Access Compliance Report Public Rights-of-Way (Curb Ramps)

Main Street: **ROLLING_RIDGE** Cross Street: **MEANDERING_TRAIL** Location: **S**

ADA ID: **RPRK211019143328** Ramp Type: **Type 4 - Parallel** Initial Pass/Fail: **Fail** Overall Compliance: **No** Severity Score: **30**

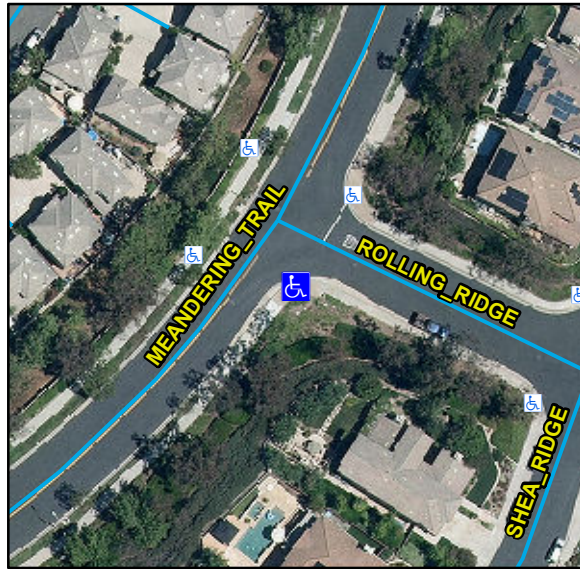
Compliance	Description	Data	Compliance	Description	Data
N/A	Ramp Length LT (in)	98	N/A	Ramp Length RT (in)	114
Yes	Ramp Width LT (in)	53	Yes	Ramp Width RT (in)	54
Yes	Ramp Run Slope LT (%)	4	Yes	Ramp Run Slope RT (%)	0.1
No	Ramp Cross Slope LT (%)	7.4	No	Ramp Cross Slope RT (%)	8.2
N/A	Landing Present	N/A	N/A	DWS Provided	N/A
N/A	Landing Length (in)	N/A	N/A	DWS Contrast	N/A
N/A	Landing Width (in)	N/A	N/A	DWS Length (in)	N/A
N/A	Landing Run Slope (%)	N/A	N/A	DWS Full Width	N/A
N/A	Landing Cross Slope (%)	N/A		DWS Offset Type	N/A
N/A	Landing Movement Obstructed?	N/A	N/A	DWS Offset Left (in)	N/A
	Landing Movement Type	N/A	N/A	DWS Offset Right (in)	N/A
N/A	Landing Shared	N/A			
N/A	Clear Space	Yes			
N/A	Clear Space To Crosswalk (in)	N/A			
N/A	Marked Crosswalk 1	No	N/A	Marked Crosswalk 2	No
	Crossing 1 Direction	NE		Crossing 2 Direction	NW
	Marked Crosswalk 1 Width (in)	N/A		Marked Crosswalk 2 Width (in)	N/A

N/A	Ramp Inside Crosswalk 1	N/A	N/A	Ramp Inside Crosswalk 2	N/A
	Crossing 1 Slope (%)	1.1		Crossing 2 Slope (%)	2.2
	Crossing 1 Cross Slope (%)	2.4		Crossing 2 Cross Slope (%)	2.6
N/A	Gutter Ponding	N/A	Yes	Curb Slope	3.3
No	Gutter Lip Height (in)	2		Road Run Slope (%)	0.8
N/A	Gutter Run Slope (%)	N/A		Road Cross Slope (%)	0.7
N/A	Gutter Cross Slope (%)	N/A	No	Perpendicular Joint Present	No
Yes	Overall Surface Condition	Acceptable			
	Cross Gutter Present?	No		Spandrel Present?	No
	Replace Cross Gutter?	N/A		Replace Spandrel?	N/A

Remove & Replace Curb Ramp With Two New Directional Ramps or Equivalent. Grind Gutter Lip.
